2101191 Street
Chowry Chase

SUBJECT: Historic Area Work Permit #478414 - Dormer window sash replacement

MONTGOMERY COUNTY HISTORIC PRESERVATION COMMISSION
STAFF REPORT

Address:	21 Quincy Street, Chevy Chase	Meeting Date:	4/09/08
Resource:	Contributing Resource Chevy Chase Village Historic District	Report Date:	4/02/08
Applicant:	Christine Weiner	Public Notice:	3/26/08
Review:	HAWP	Tax Credit:	None
Case Number:	35/13-08F	Staff:	Anne Fothergill
PROPOSAL:	Sash replacement in dormer windows

A-3

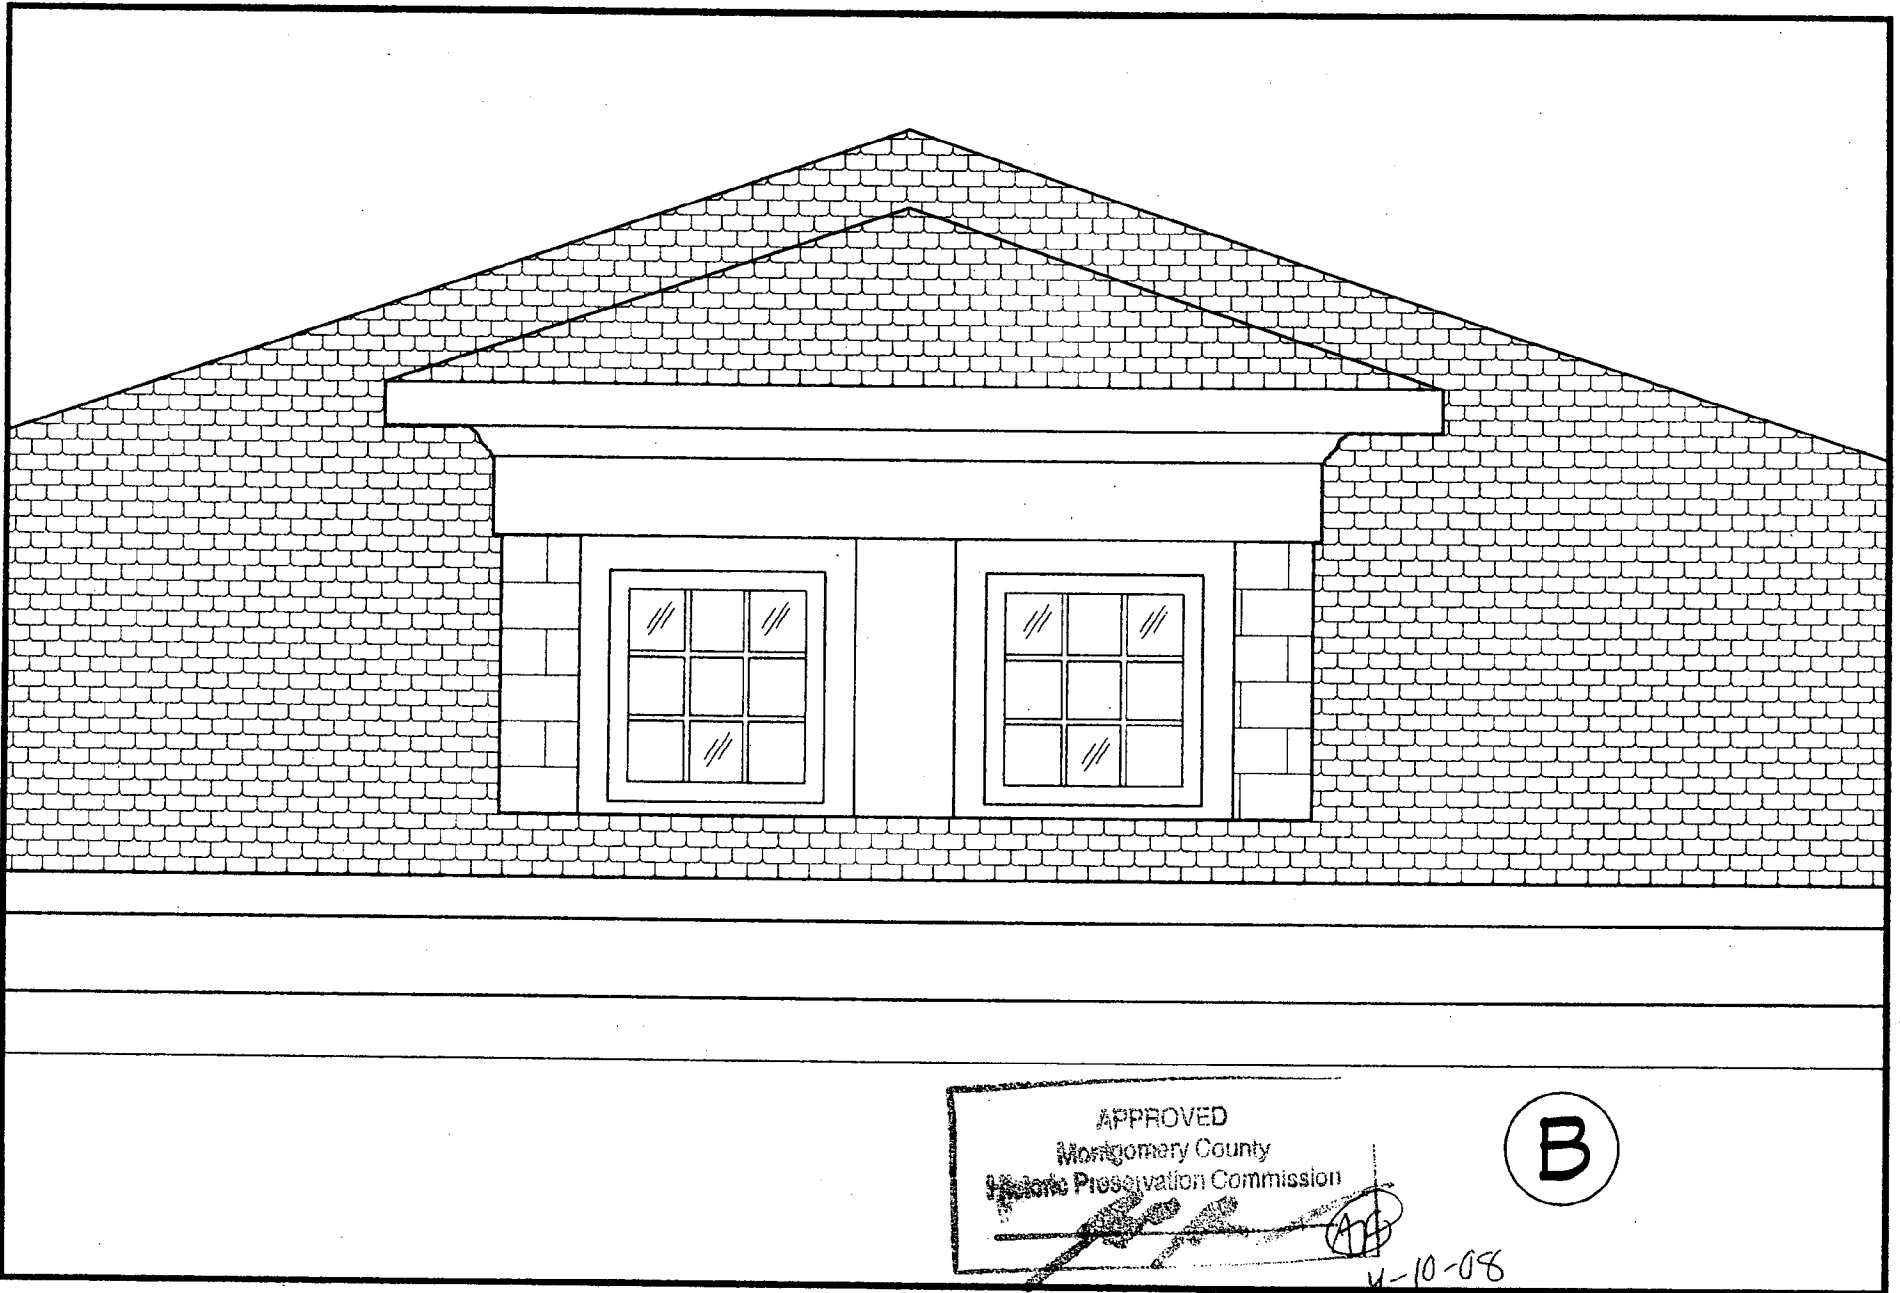
**PAISNER WINDOW REPLACEMENT
 TYP. PROPOSED WINDOW ELEVATION**
